PULSIPHER FARMS · LOGANDALE, NEVADA · CHRISTMAS TRAIN (PF-CT)

Powered truck + final drive / motor mounting (Ø1,450, MS05 + chain; detail L-103.2)

Sheet L-103 · REV L4.2 · 2026-10-28 · 1:25 at 17x11

PULSIPHER FARMS CHRISTMAS TRAIN — PRELIMINARY, NOT FOR CONSTRUCTION UNTIL PE STAMPED

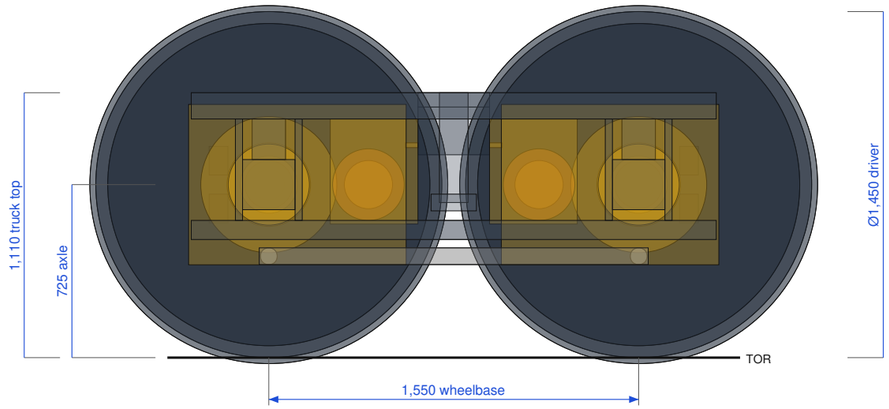
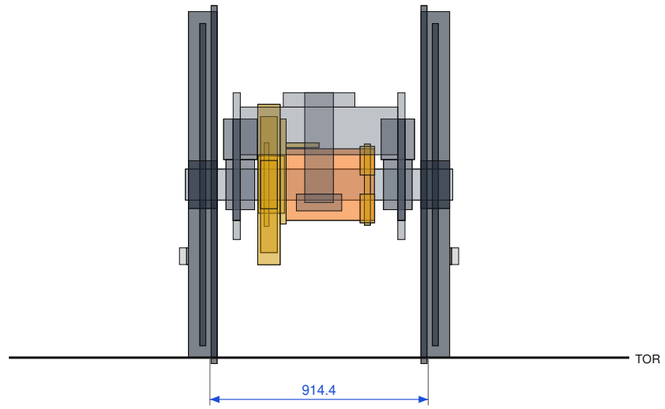
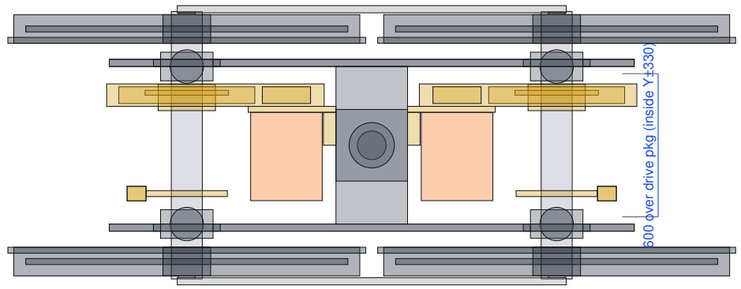
REV L1: plan LT18-LT20 truck - inside sideframes Y±330-360,
top Z1110; drivers Ø1,450 exposed outside; flange gap 50 in truck.
Transom PL16 box; pivot seat + Ø100 spherical pivot (LT20 GE100ES-2RS cand.).
REV L4 per axle (Y-): 45T 120-2 split rim ring bolted to a Ø150 pressed flanged hub
(no key, SHRINK 0.15-0.20), 54-link chain C417.6 to a 15T
on MS05 shaft code 5 W55x3x17; motor on PL25 slotted bracket under transom
(4x M20 10.9, 2 jack screws, 37 mm slide); oil-bath case Y-257..-163,
Z389-1061 (>=15 radial at 3% + travel), floating seal plate. Clear: case 3 / hub 5 to
spring reservation, motor 57 (23 at 3% stretch) to transom.
Disc Ø340x25 on axle Y+ + 2 spring calipers (B1-g), unchanged.
Removed: Dodge TA7315H15MS, H1B110, belt drop, TA rod.
AWAIT: Poclain AE (radial/offset, spline); chain/sprocket maker.
Inside axleboxes AWAIT bearing; primary springs AWAIT (LT35).
Anti-slip (L4.1): NO flow divider - PLUS+1 traction control, pony 3rd pickup (sand deleted).

L4.2: LOW TRACTION PIN Ø120 4140 + GE120ES housing under transom at Z650
(X4075/7275, calc L42-tp); centre plate flat-lined (vertical only). Bump stops ±22.
Sanders DELETED (11/2026); hill-hold kept; flange withdraw 28,
re-profile <= 27 (all wheels); P-103-1 hanger L-weld + 2 PL16 gussets (Loco Bot L-103).
